Preliminary and Final DRAINAGE PLAN AND REPORT ROCKY TOP MOTEL AND CAMPGROUND

County File No.: PPR2140

EPC STORMWATER REVIEW COMMENTS
IN ORANGE BOXES WITH BLACK TEXT

SUBJECT: Drainage Plan and Report
Rocky Top Motel and Campground

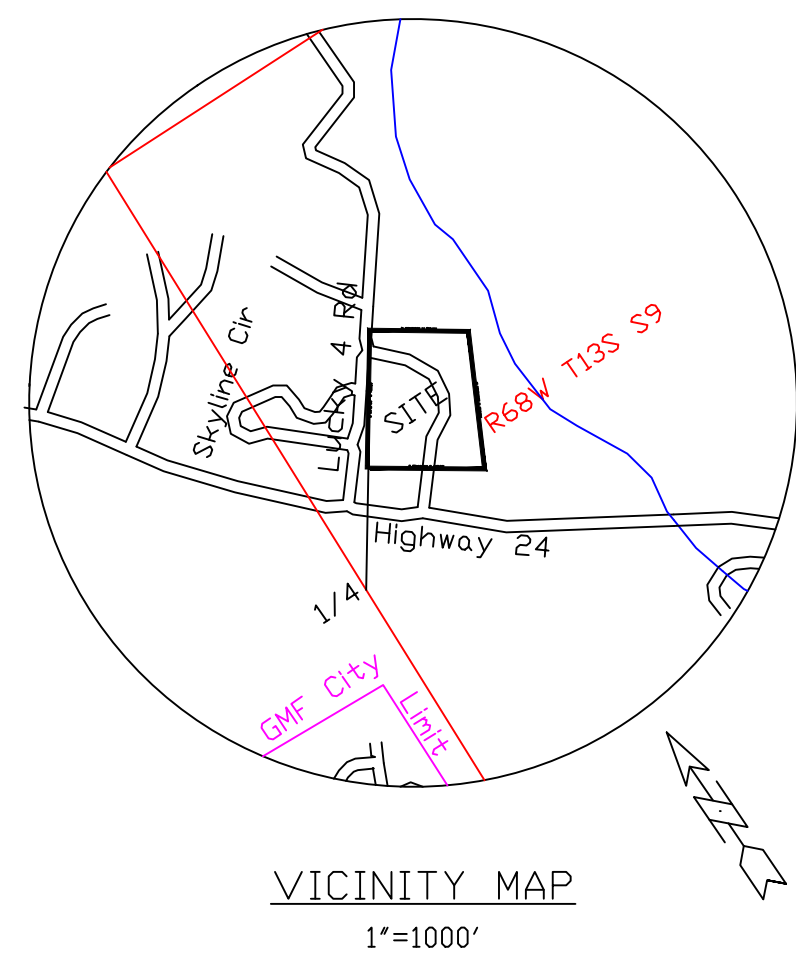
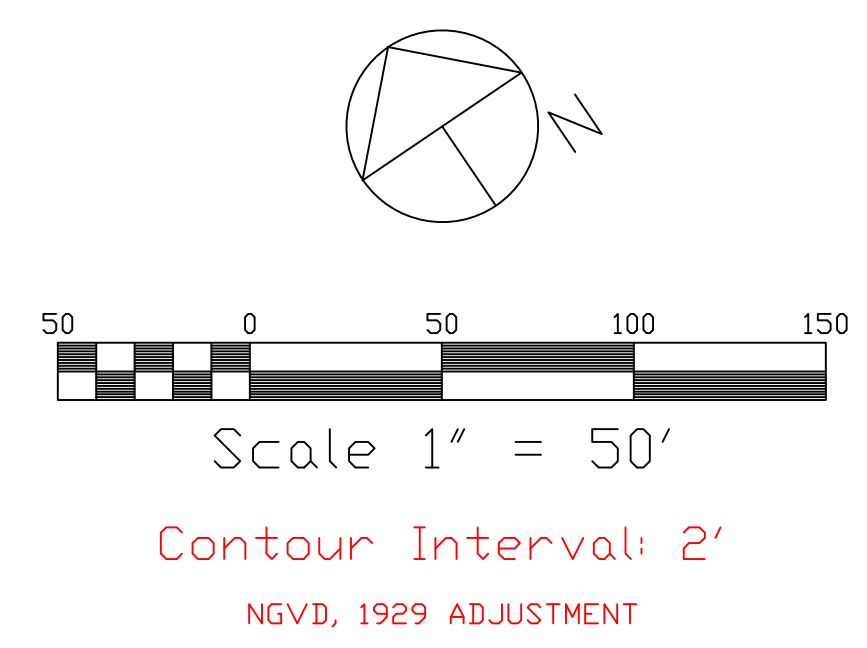
Per comment on UD-BMP spreadsheets above, delineate approximate areas tributary to each pond, with excluded areas also clearly delineated. It might be best to do this on a separate map so this map does not become too busy.
